Errata for
Introduction to Structural
Dynamics and Aeroelasticity, Second Edition

Dewey H. Hodges and G. Alvin Pierce
Errors in Third Printing (corrected in Fourth Printing)

March 11, 2015

Figure 5.18: Schematic of interaction between analysis and test in certification; from Niedermeyer (2014), Federal Aviation Administration, used with permission

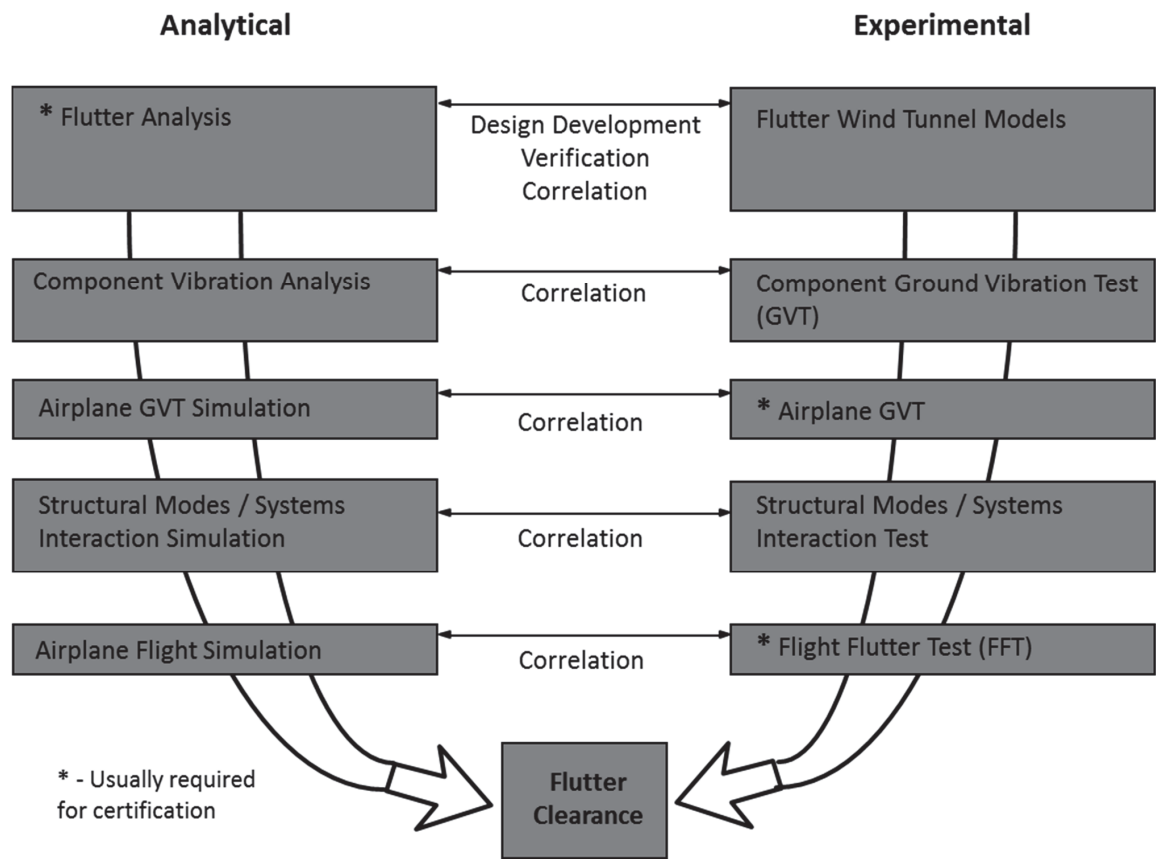
- 221 Add the following paragraph just before Section 5.8.1: Analysis is a key part of the requirements in the specifications and regulations. As an example, it establishes the critical configurations and areas of the envelope where flutter may be a concern. Testing is used to validate the analytical work. However, some specifications and regulations also directly require testing as a separate action, beyond the purpose of validating the analytical work. For instance, ground vibration testing to determine the natural frequencies and mode shapes, while a vital part of analytical validation, is also an independent requirement in some regulations. Similarly, flight flutter testing is a specific required demonstration that the aircraft is free from aeroelastic instabilities and meets the damping requirements. After the initial design is completed, there will be on-going modifications and configurations to address such as stores arrangements on military aircraft. Combinations of analysis and testing will, therefore, be a continual, integrated process to verify the design; see Fig. 5.18.
